**Flood Control Project Maintenance
Levee Inspections**

Maintenance Issue Types Only, Levee Inspection Report By Mile - Spring 2020

Brannan Andrus Levee Maintenance District

Waterway	Bank	Unit Miles	Inspection Start/End	Inspector
Unit No. 01 Georgiana Slough	Right	6.01	04/02/2020 04/02/2020	David Julian

Photo 1 of 2 : SP_2020_NA0002_63_75_20200304_00039.jpg

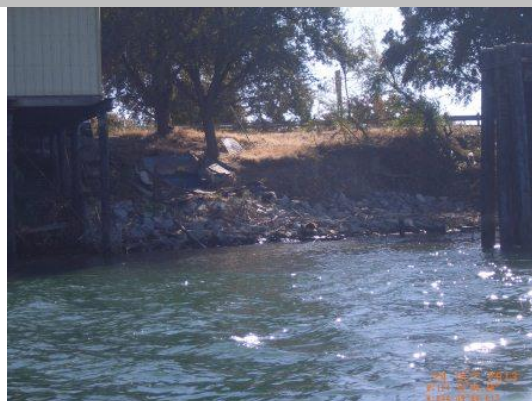
LM Start	3.43	Rating **	U	Issue No.	75
LM End	3.56	Issue Type +	Ma	Location *	WS
Category	Supplemental			GPS Latitude/Longitude	
				Start	End
Item	2017 USACE Erosion Survey			38.162459 °	38.162828 °
				-121.613848 °	-121.616263 °
DWR ID	DWR_NA0002_02_f_2018_75				
Comment Code

2017 Site ID: SAC 17.2 L
Status: Critical
2017 Field Notes: More rock has been placed in spots along the toe, but it is still insufficient.
Site History: 2009 - Fluvial erosion, into the levee slope, close to vertical bank with roadway on top. Pilings that were once at the bankline are now 30 ft out. 2010 - Very steep slope with slumps and overturned trees. 2011 - Upgraded to CRITICAL. Sections of vertical slope with highway on top. Heavy vegetation in front of most of the erosion pockets. Structures built into the levee on the upstream end. 2012 - Site continues to worsen. 2013 - Some rock added on the upstream end, but site remains critical.
2018: Site with erosion almost into roadway still there. Keep as critical.
